**DEPARTMENT OF MILITARY AFFAIRS
CFMO CONTRACTING BRANCH
ISSUED ADDENDUM**

ADDENDUM # TWO

Project # FMO 212041

Project Name: Cecil Field Building 1822 Renovation

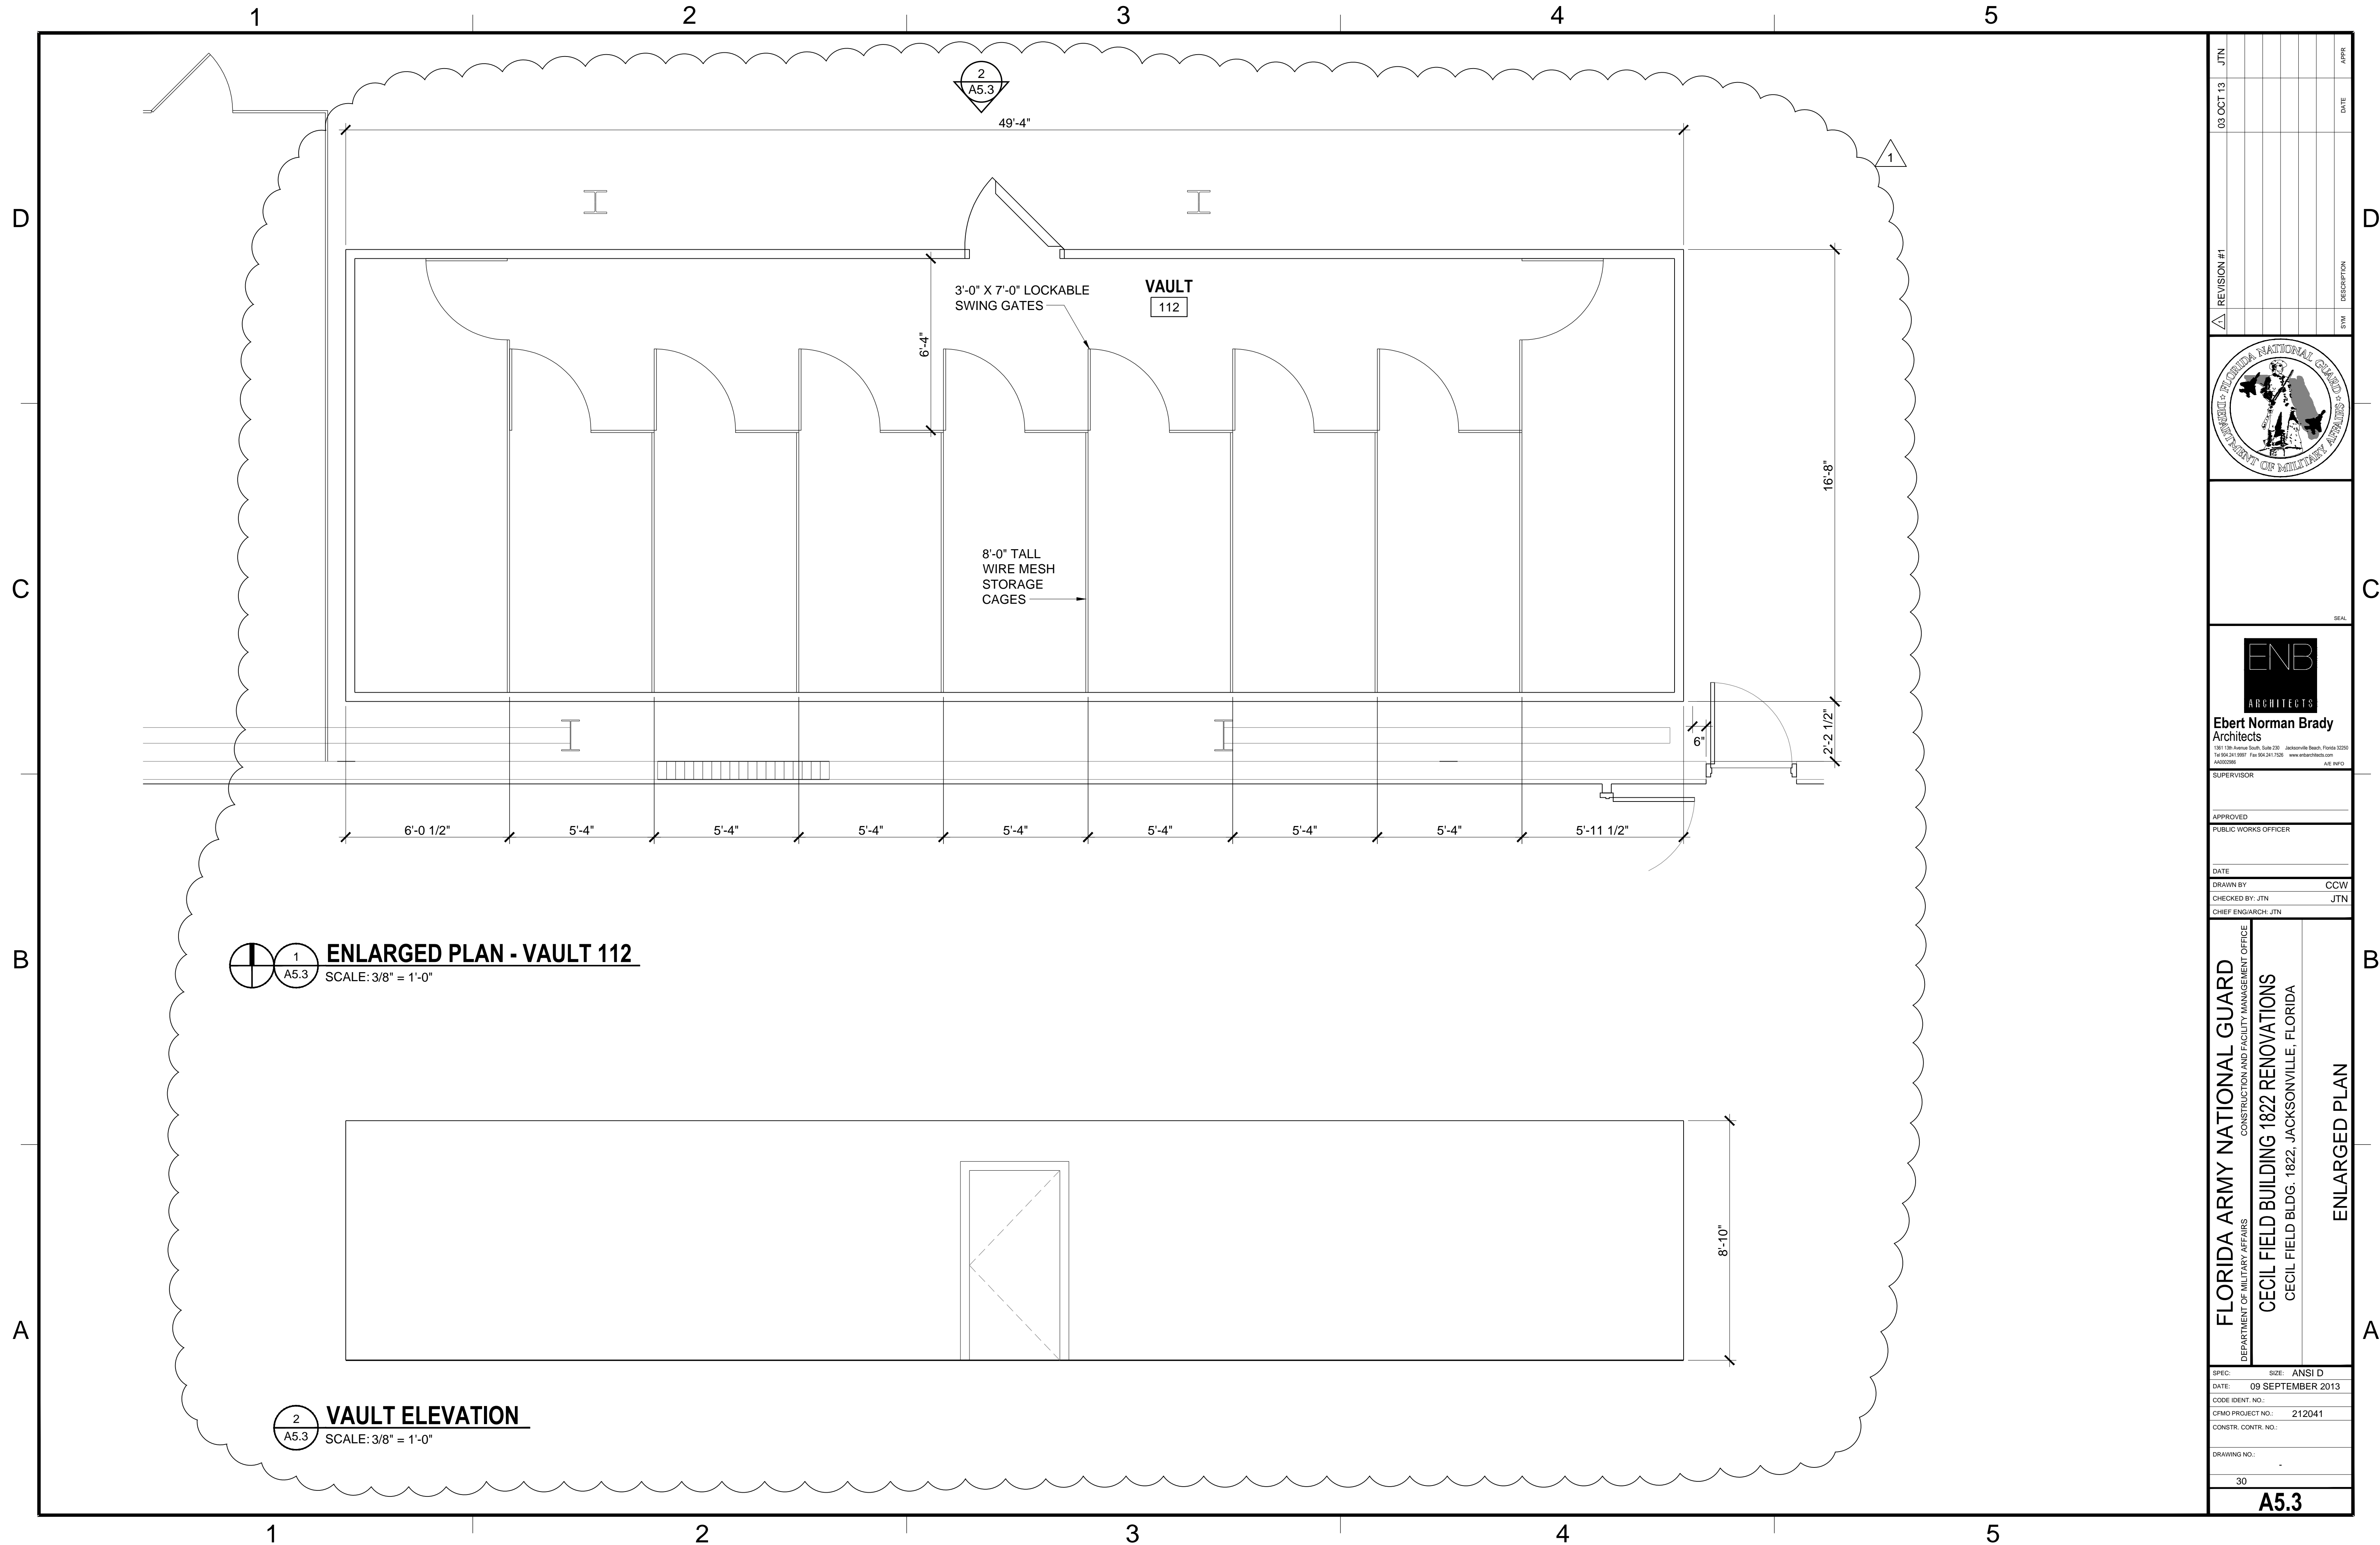
- **Question:** *Gentlemen, We are going to bid the helical pier part of this project. Do you have any geotechnical boring data? Is the cited 5 ton capacity a design capacity or ultimate? Please advise. Bill C. McMahan Jr. P.E., Principal Engineer/ Vice President, Foundation Systems, Phone: (904)241-4425.*

Response: From Jude Kostage, Structural Engineer: As per general note 240.1, the 5 ton load is an allowable load. There is no geotechnical report for this specific building. However attached is a boring log for a building in the vicinity.
